TR-5310-1
REVISION 2

MARK I CONTAINMENT PROGRAM

PLANT-UNIQUE ANALYSIS REPORT
OF THE
TORUS SUPPRESSION CHAMBER
FOR
PILGRIM STATION - UNIT 1

TECHNICAL REPORT TR-5310-1
REVISION 2

VENT HEADER MODEL

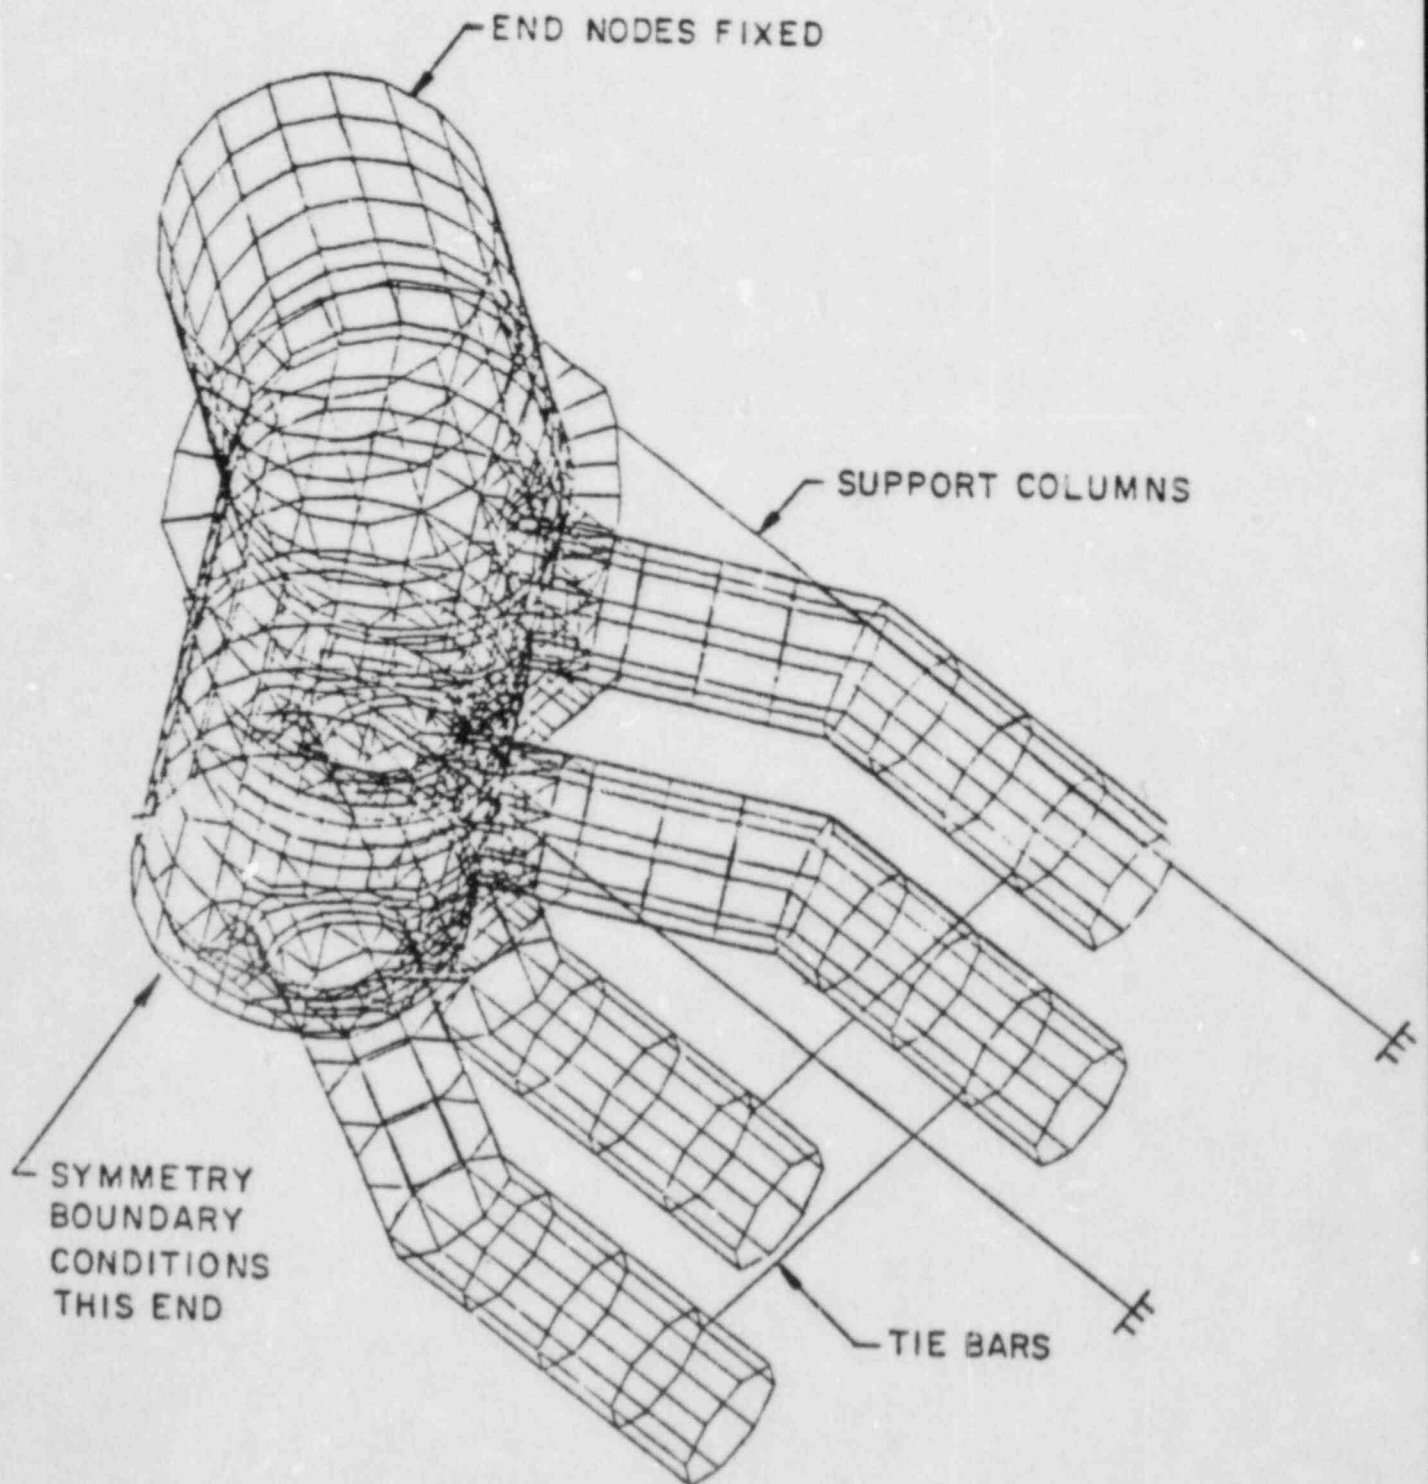
ITEM 3: PUAR Section 4.3.3.1

It is stated that "the combined effects of the CO downcomer loads (are) bounded by CH lateral loads".

Does this apply to the entire vent-header/downcomer system as well as the individual downcomer pairs? The LDR specifies the CO loading on the entire vent-header/downcomer system as the worst of eight different phasing combinations of the loads on the various downcomer pairs in the system. Were these considered, and was the worst of them bounded by the chugging load?

For the individual downcomers:

- The eight/CO phasing combinations on various downcomer pairs were considered and bounded by the chugging load.

EQUIVALENT SRV DRAG FROM IN PLANT TESTING

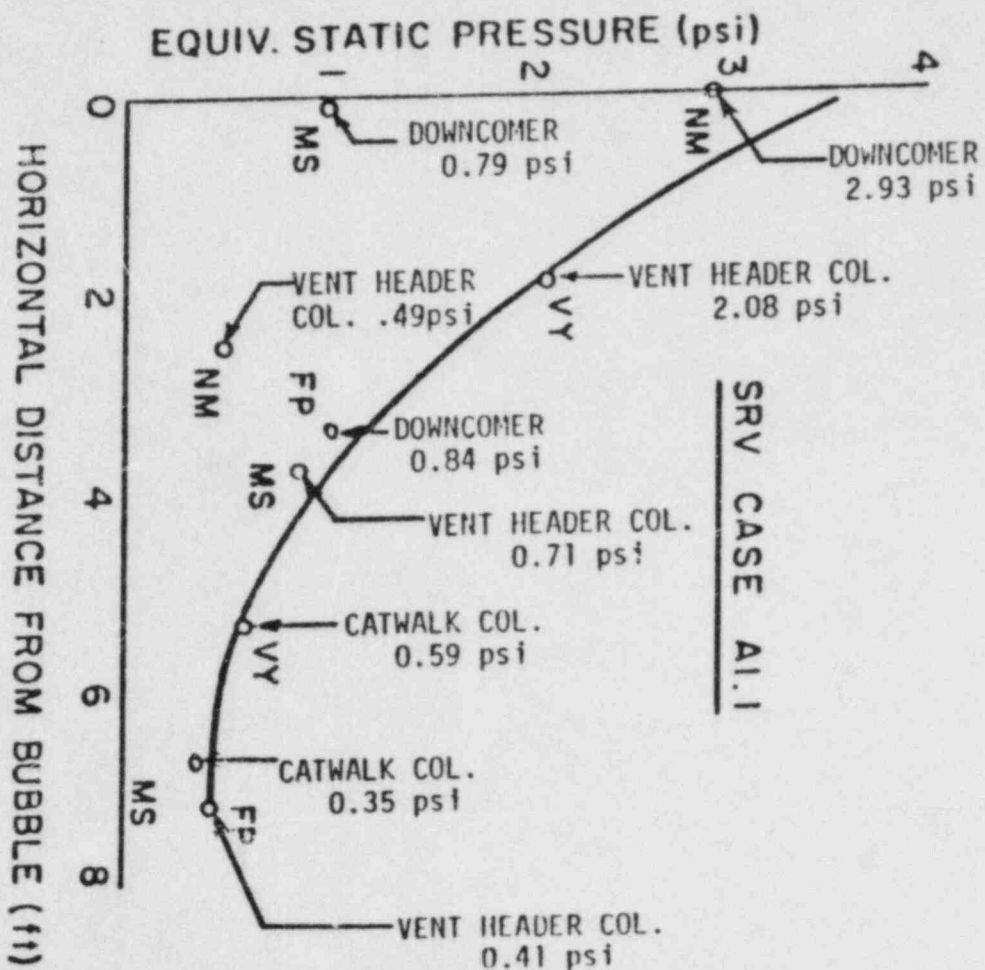
With regard to the Table on page A1-4 and Figure A1-7, justify the inclusion of data from Nine Mile Point which uses a quencher device radically different from the other three plants included in the data base.

Identify any structures for which SRV drag allowable margins are less than 3.0 and state what the margins are. In other words, list those structures which would be stressed beyond allowable limits if SRV drag loads were increased 3.0 times in Pilgrim and provide the margins for these structures.

- Inclusion of Nine Mile Point data in Figure A1-5 was done to illustrate the comparative results for the two devices. This data did not affect the resulting curve used in analysis.

- See attached table for safety margins.

SECTION A-A - ELEVATION
 LOCAL SENSOR BAY
 (TYPICAL @ L - 6 BAYS
 THESE BAYS HAVE S RV
 QUENCHERS)

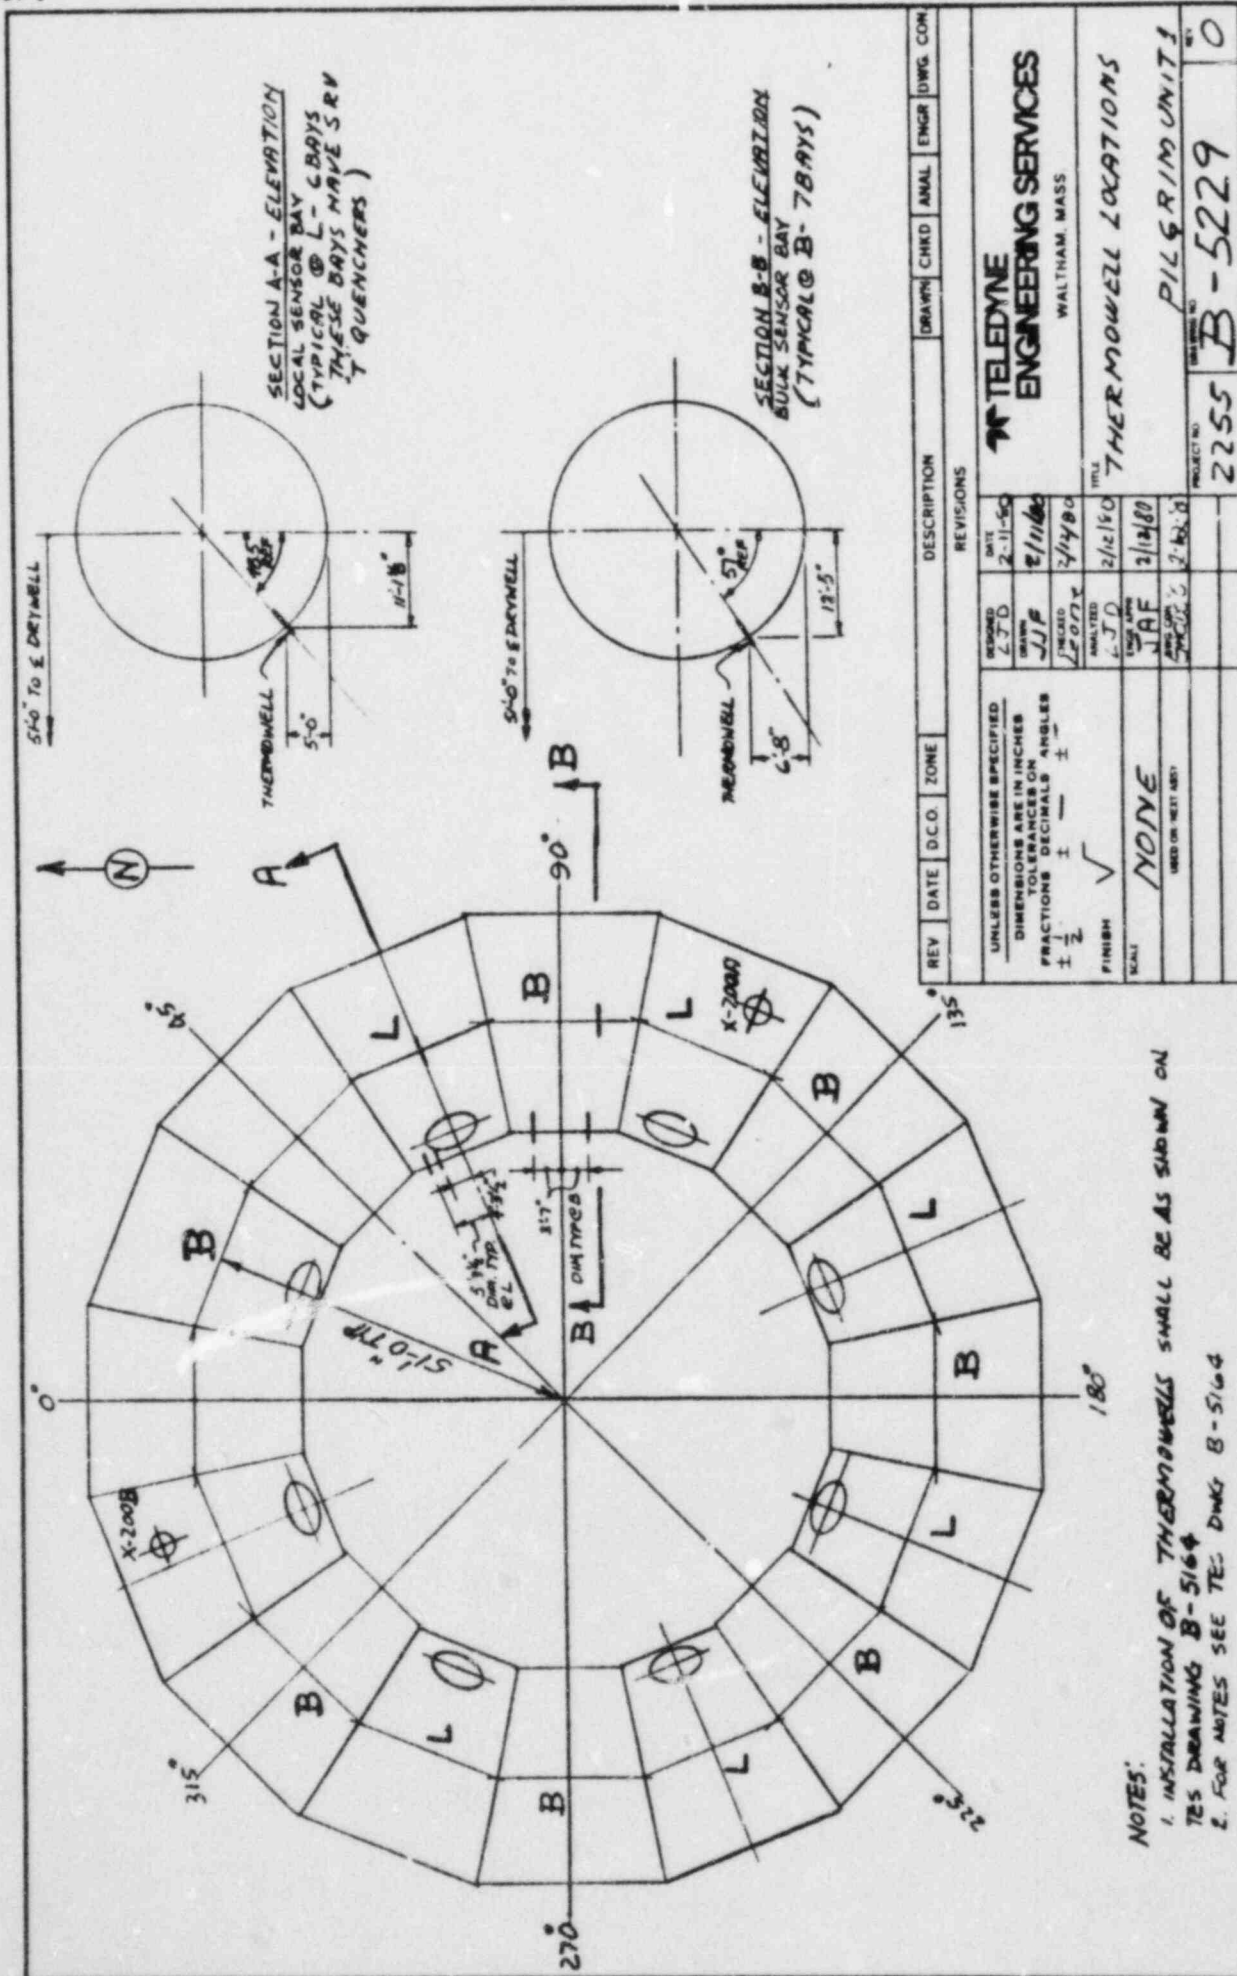
ITEM 7: PUAR Sction 2.2.1

What is the vertical location of the pool temperature sensors with respect to the centerline of the T-quenchers?

- Sensor locations are shown on the following drawings.
- The centerline of the T-quenchers is 5'-0" from torus bottom.
